West Capital Airpark Phase 1B-2 Residential (Novatech Phase 2B) Servicing Report

West Capital Airpark – Phase 1B-2 Residential
1500 Thomas Argue Road
Ottawa, Ontario
Servicing Report

**Reference: West Capital Airpark – Phase 1B-2 Residential
Site Servicing Report
Our File No: 102085
City File No.: D07-16-22-0017**

This report has been revised to address comments from the City of Ottawa as indicated in the cover letter. The City review comments and response to comments are included in **Appendix A** for reference.

City of Ottawa Stormwater Operations Comments Received via email attachment June 13, 2024

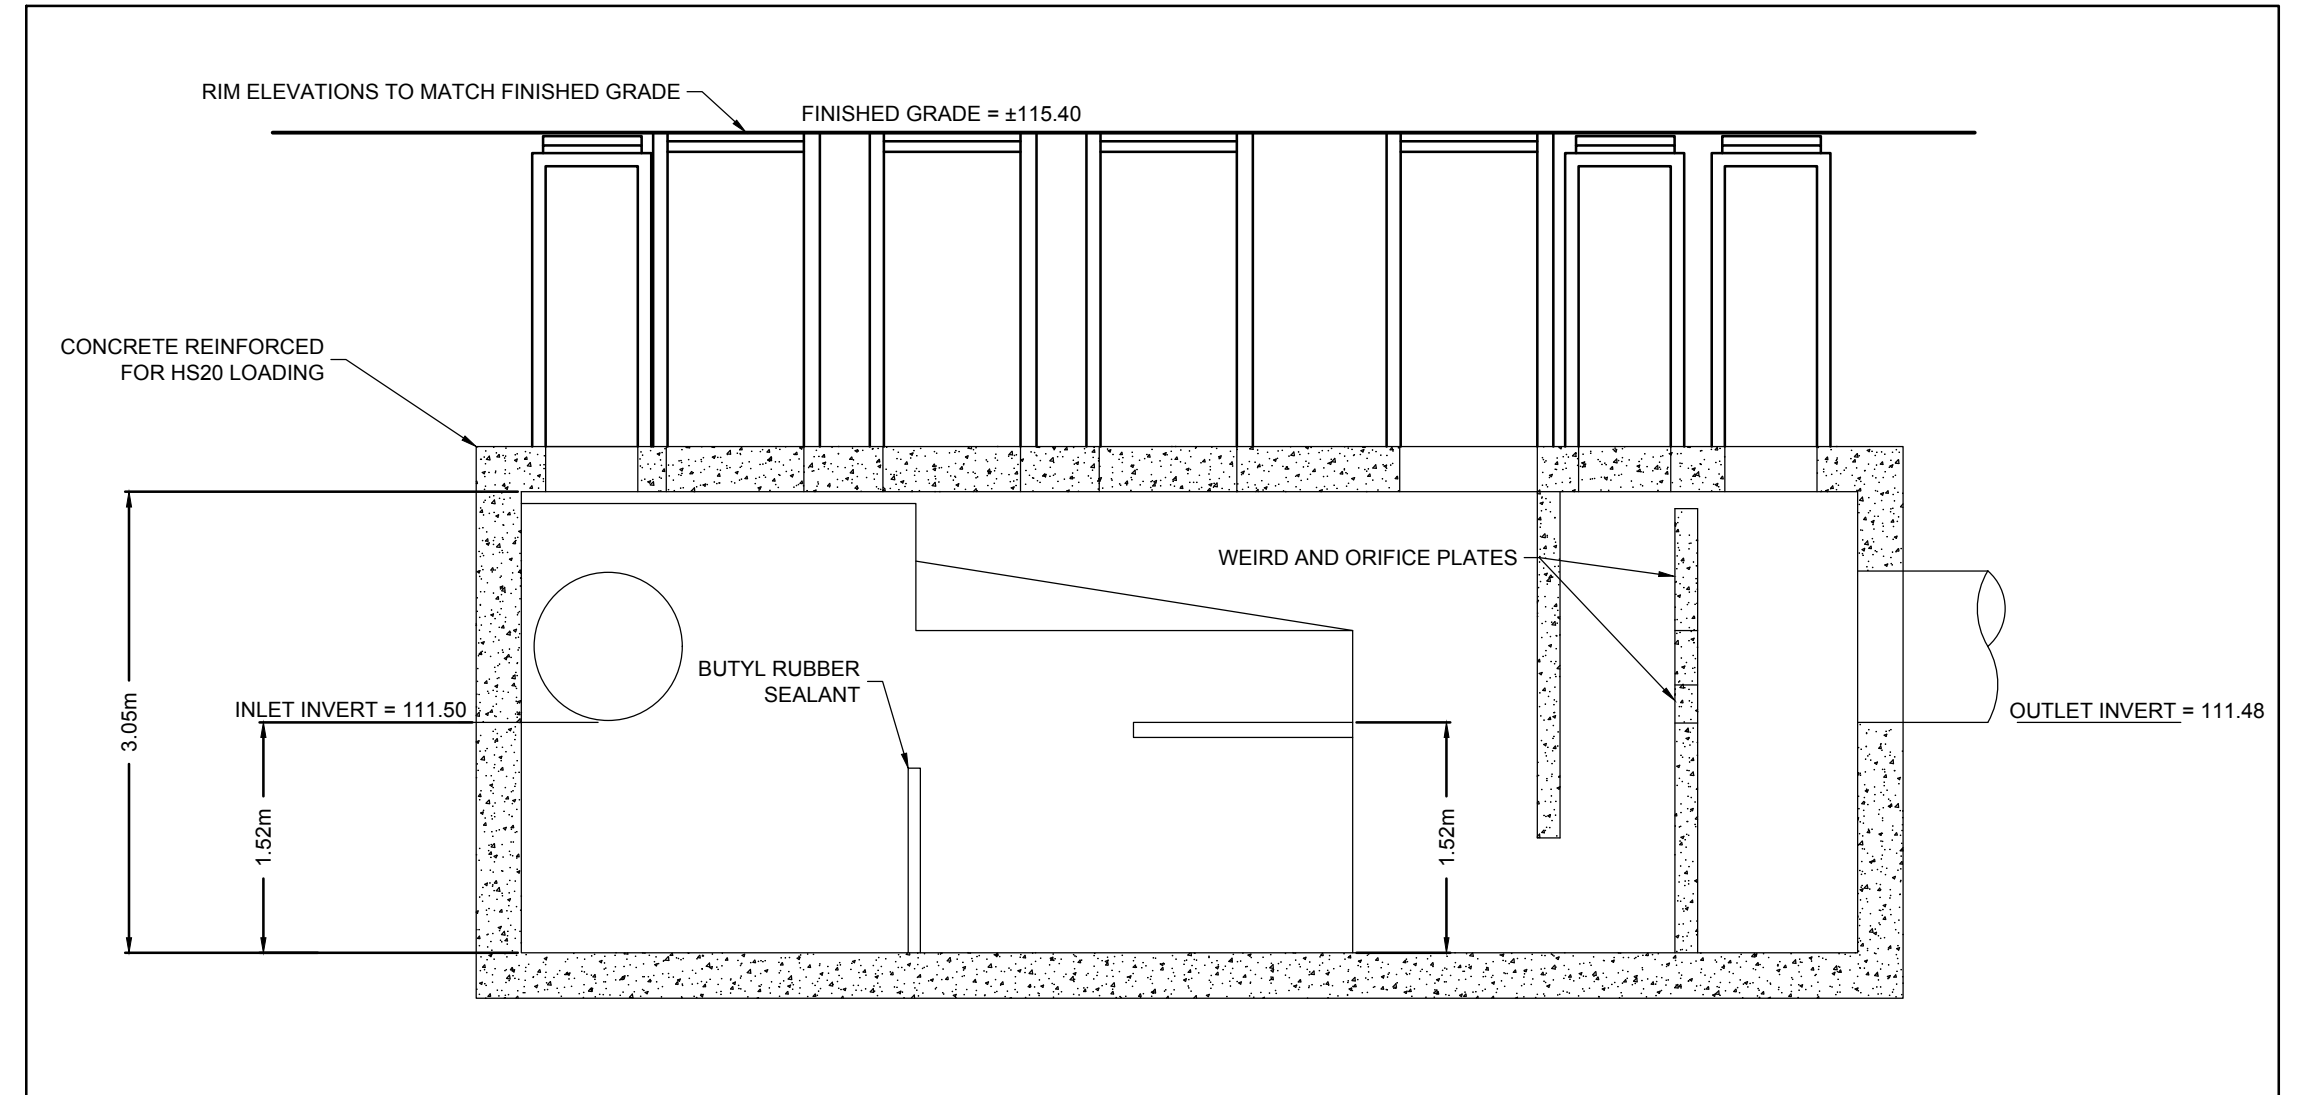
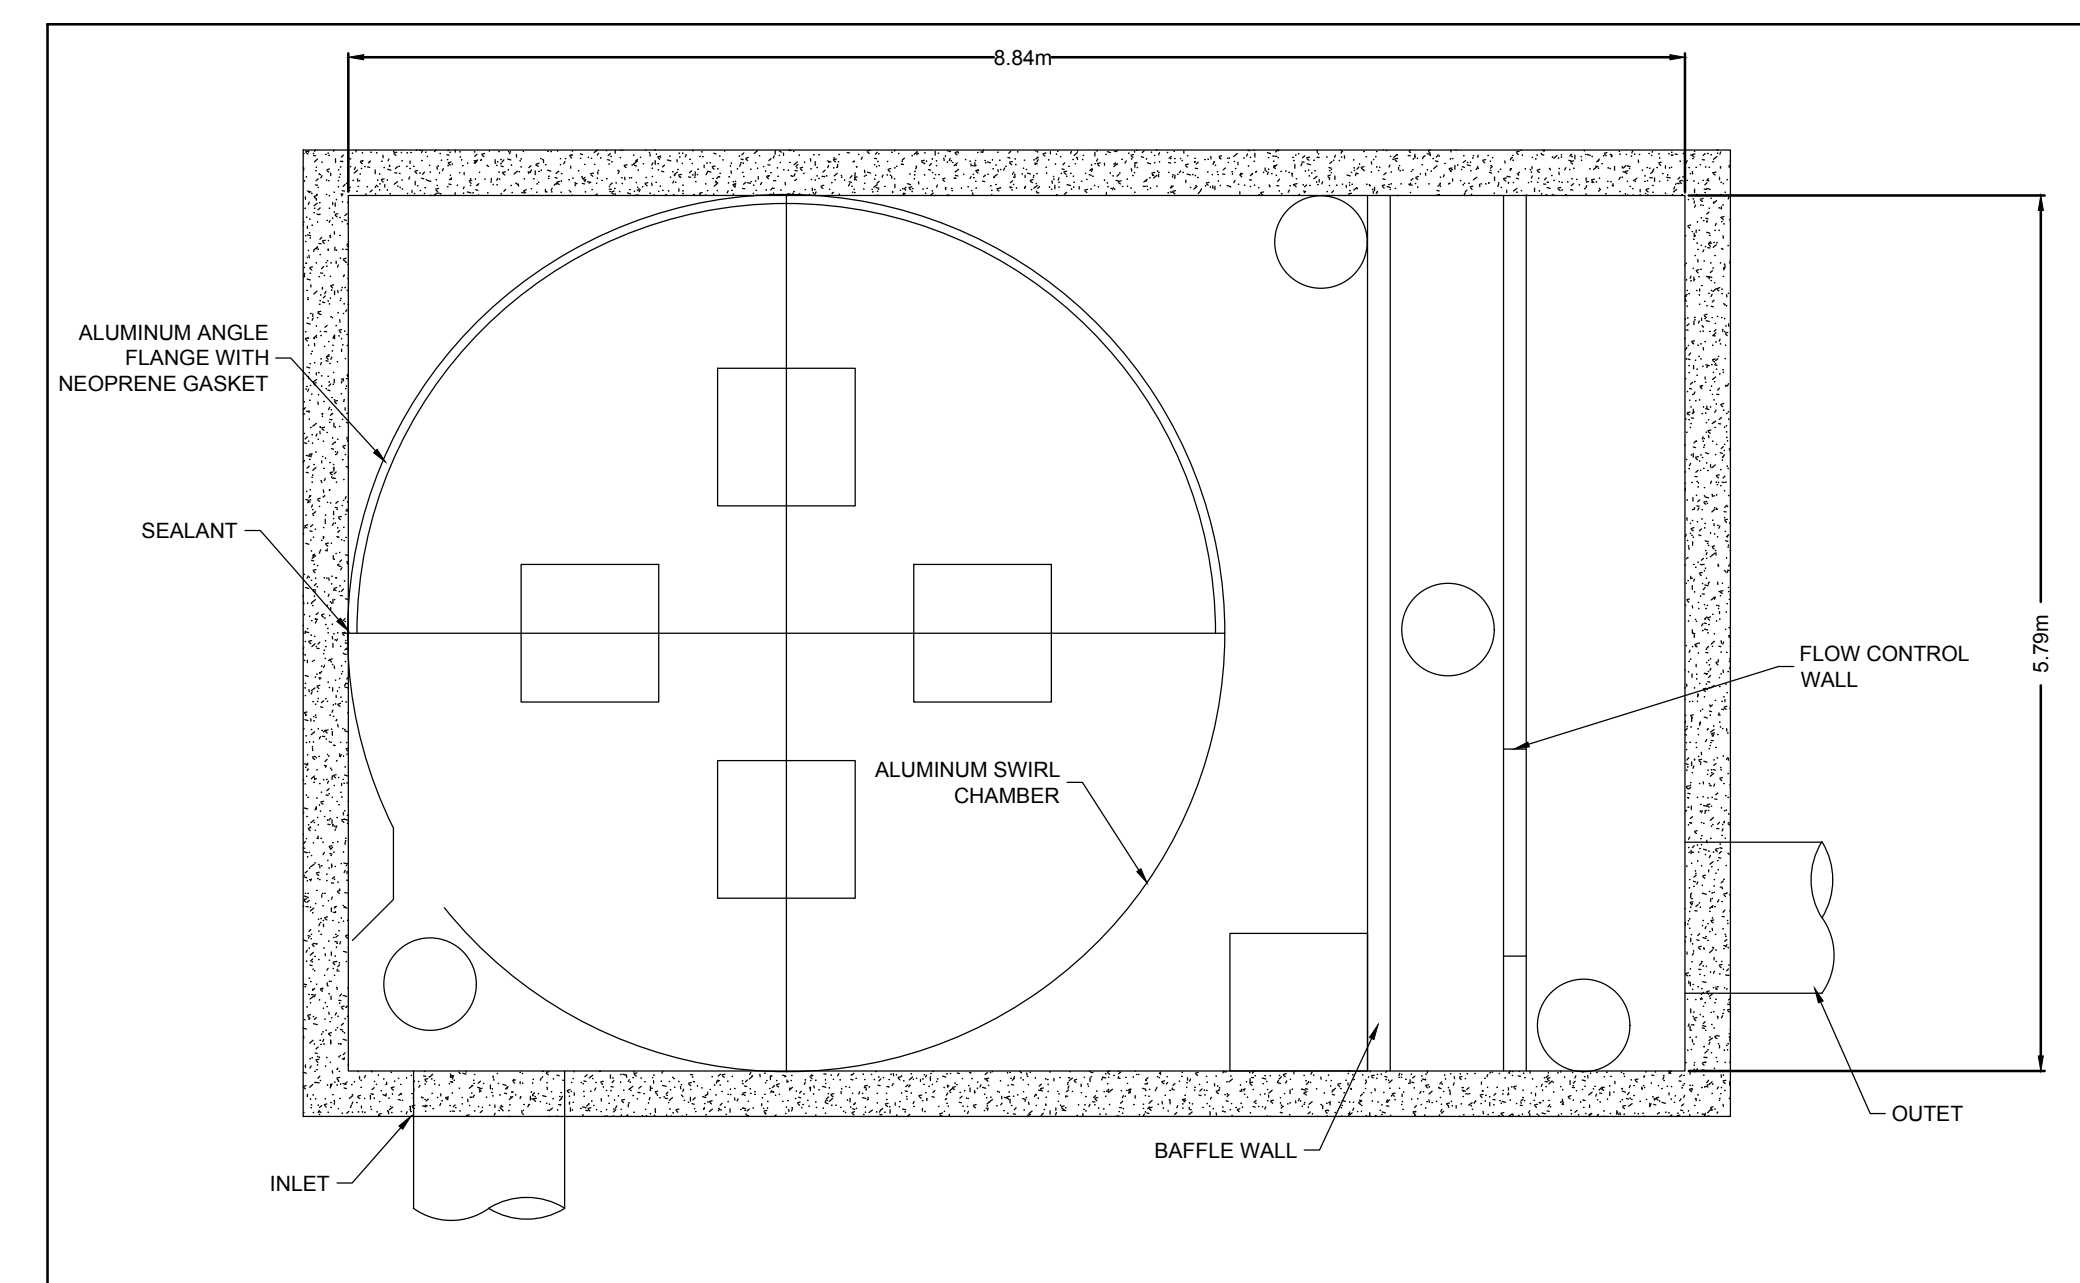
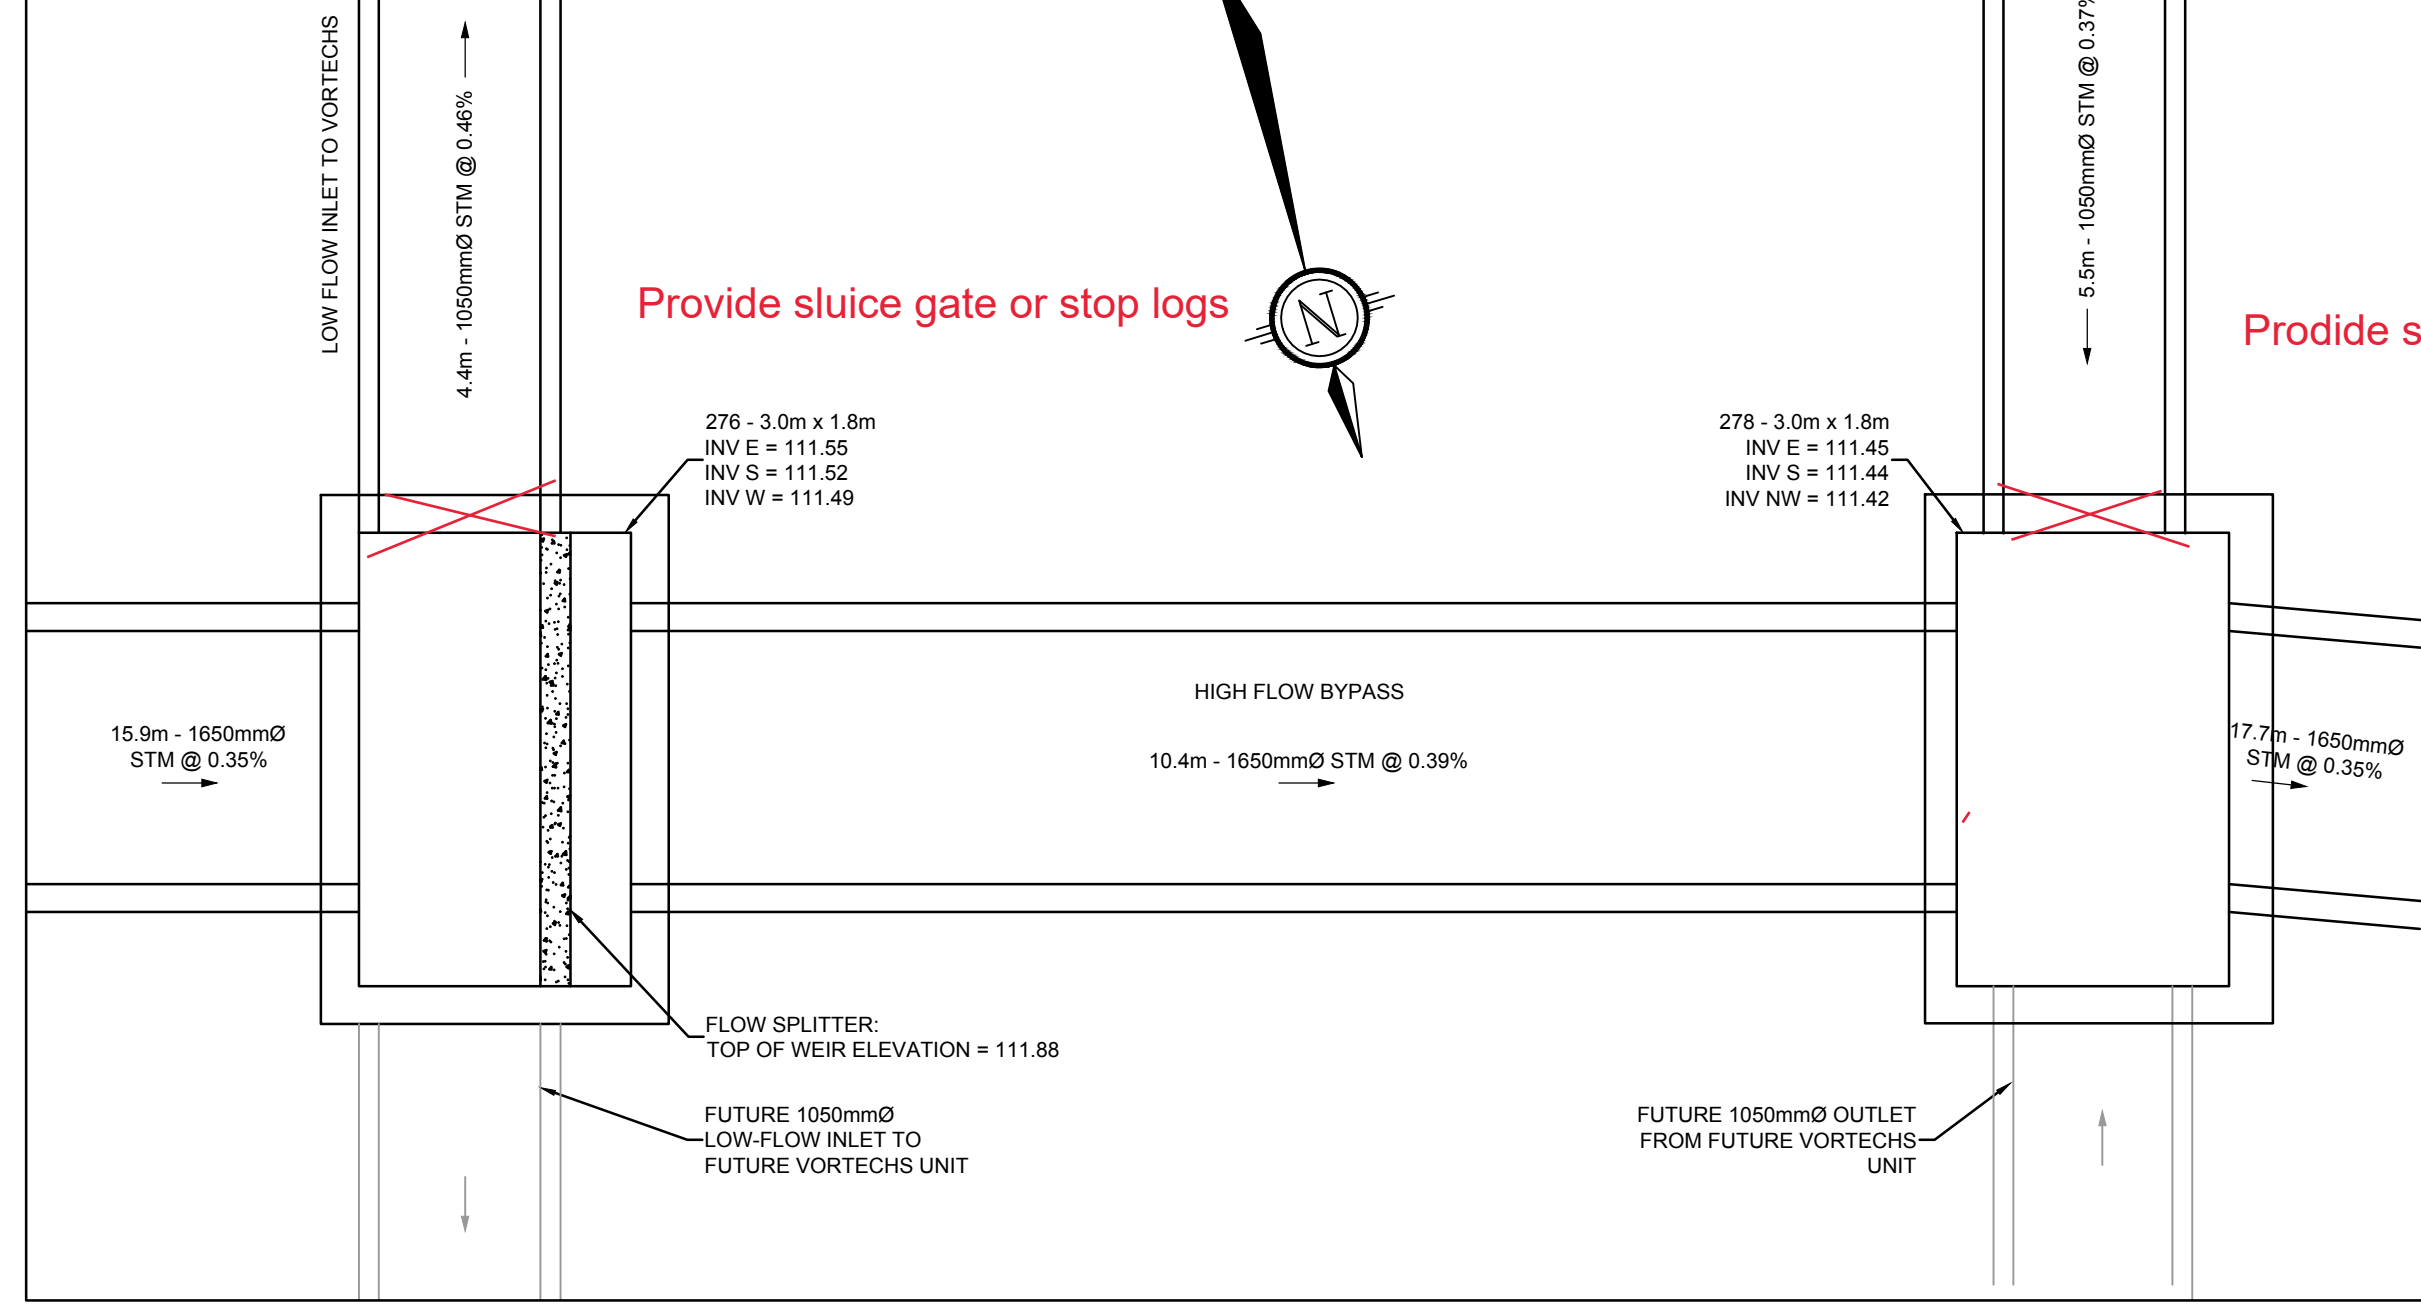
5	Who will be responsible for maintaining the rear yard infiltration trench while it's in the place? Please provide a service road parallel to the trench.	Maintenance of the rear yard infiltration trench would be the responsibility of the homeowners. This is consistent with standard City of Ottawa projects with a rear yard subdrain / infiltration system. Outlet catchbasins have been proposed within the ROW as part of the rear yard infiltration system and would provide maintenance access to the infiltration trench.No service road will be provided through the residential rear yards.	OK
6	Lastly the off-line Oil Grid separators must be provided with the gate to provide efficient maintenance.	The Stormwater Management Facility is a dry pond system and will not require the installation of gates in order to access the oil-grit separator for maintenance.

The sluice gates or stoplogs are required to isolate the OGS unit during the cleanup process
